Department of Energy

**Ohio Field Office
Fernald Area Office**

TRANSMITTAL OF VARIANCES TO PROJECT SPECIFIC PLANS

VARIANCE / FIELD CHANGE NOTICE

FIGURE 2-X. STP INCINERATOR BORING LOCATIONS Page 2 of 4

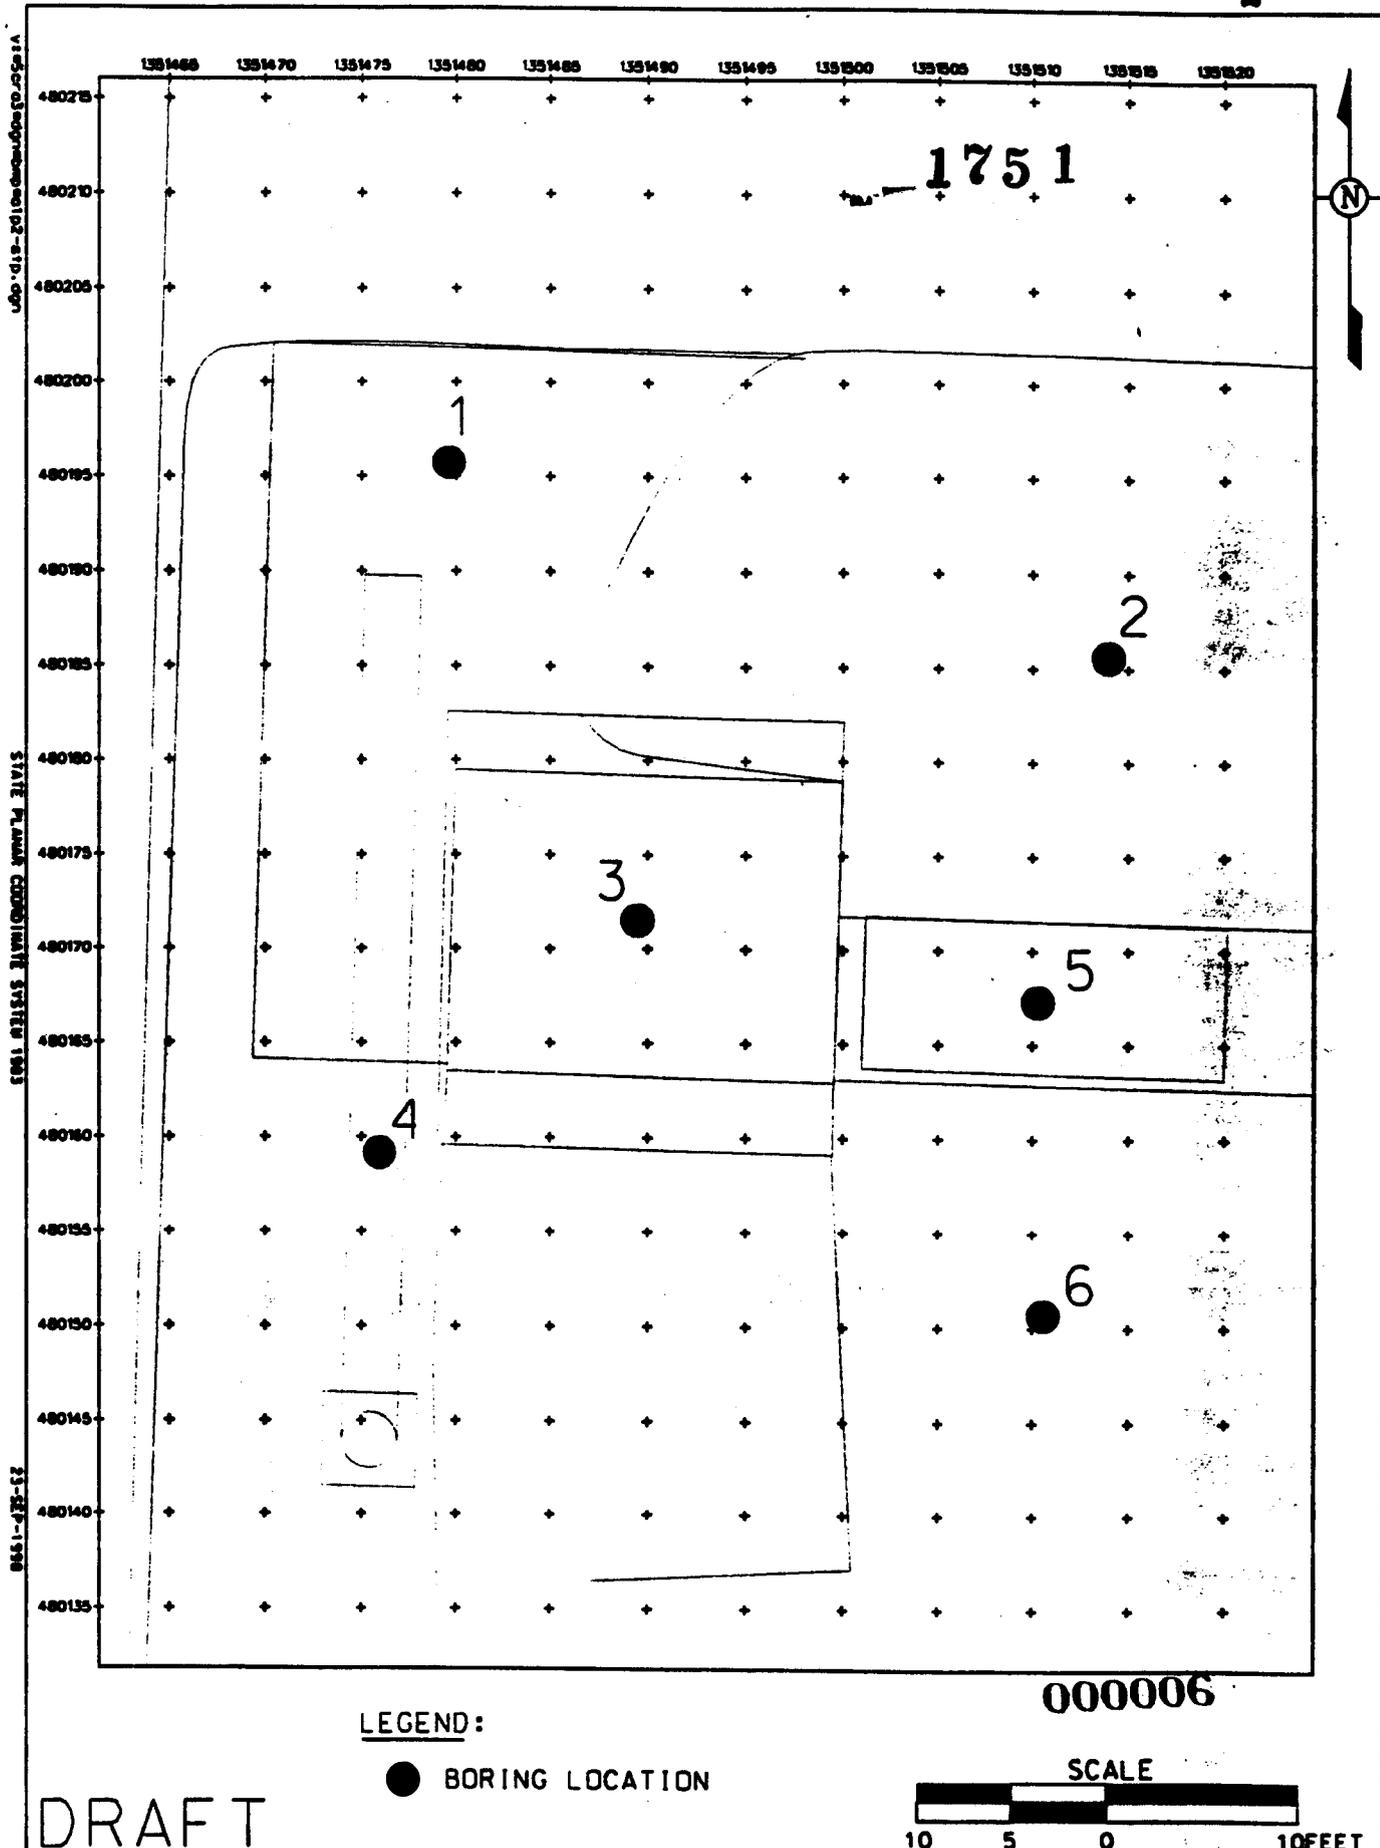
This variance provides justification for collection of additional samples in the STP Incinerator area. Samples will be collected from six different borings in the locations. The attached figure shows the location of the borings and the following table lists the boring number and coordinates.

Locations may be changed depending on field conditions up 3 feet.

Each boring will be advanced to a depth of 5.5 feet, with samples taken and submitted for analysis at the following intervals: 0 - 0.5', 0.5 - 1.0', 1.0 - 1.5'. The following intervals will be collected and archived: 1.5 - 2.0', 2.0 - 2.5', 3.0 - 3.5', 4.0 - 4.5', 5.0 - 5.5'. Note that the 0 - 0.5' interval begins below the existing concrete pad. These samples may be submitted for analysis if the analyses of the above intervals show contamination. Samples will be analyzed for Total Uranium and technetium-99. The attached table lists the sample ID and coordinates. Field QC (duplicates and rinsates) are identified in the attached table. A rinsate will be collected at the beginning of the sampling event and at the end.
